Subject: - VISIT OF THE INSPECTION TEAM REGARDING THE INSPECTION OF THE PROJECTS OF E&SE DEPARTMENT.

Subject: **INSPECTION REPORT REGARDING SCHEMES UNDER KP-HCIP PROJECT IN DISTRICT PESHAWAR**

Name of Project:	200166-Refugees & Host Communities under IDA-18-Regional Sub Window SH: Khyber Pakhtunkhwa Human Capital Investment Project (KPHCIP) Education Component		
Contract Package/Phase	Listed below	District:	Peshawar
Visited By:	Inspection Committee		
Date of visit:	15 Oct, 2025		
AA Cost:	Listed below	Bid Cost:	Listed below
Date of Work Order & Completion Period:	Not provided	Technical Sanction Cost & Date:	Not yet sanctioned.
Executing Agency:	PMU KP-HCIP		
Contractor/Firm:	Listed Below	Consultant	Sunjin Engineering & Architects JV NEC
Visit type	Special Task	Observation type	Critical
Coordination with Inspection Team:	Not satisfactory	Data Availability to Monitoring Team:	Partially Provided
Availability of Approved Drawings at site:	Provided but not dully signed and stamped by the PMU.		
Implementation Schedule:	No updated work schedule available.		
Material Testing Profile maintained at site:	Not Provided	Site Register	Not Maintained

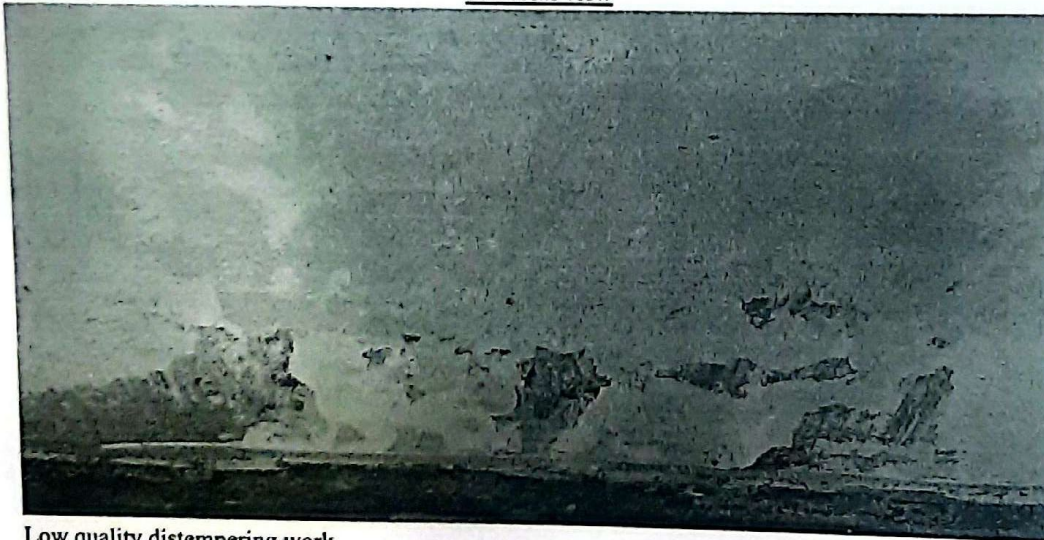
- III. The false ceiling work was found of poor workmanship, made with low-quality 2×2 ceiling tiles that were non-uniform in color and texture. The installation was uneven and visually inconsistent with approved samples and specifications.

Low quality distempering work

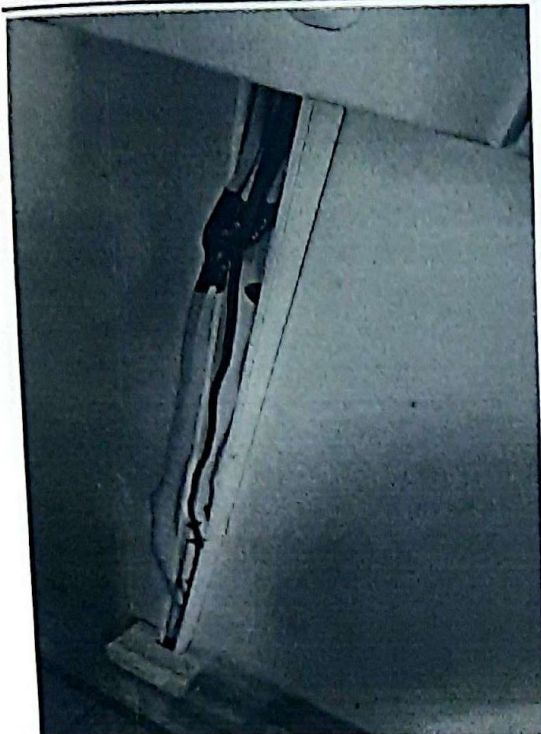
- I. The building's internal walls were distempered without properly scraping the old paint and loose surface layers. Despite this, the contractor has already been paid for surface scraping as per the BOQ item.
- II. Internal wiring was observed to be of inferior quality and not conforming to approved specifications. Notably, 3/29-gauge wire was used for power plugs, which is unsafe and below the minimum standard (expected 7/29 or 7/36) required for socket outlets. The wiring was also found cut at short distances and improperly jointed without junction boxes or proper insulation.

- I. The distemper work shall be re-executed after complete scraping and cleaning of existing surfaces. Payment already made for scraping should be recovered or adjusted as per the consultant's verification.
- II. The contractor shall remove and replace all unsafe or substandard wiring with approved copper conductor PVC-insulated wire, properly jointed and tested for insulation resistance.
- III. False ceiling tiles should be replaced with first-quality, same-color 2×2 ceiling panels meeting the approved brand and specifications. Proper alignment, level, and uniformity should be ensured under the consultant's supervision.
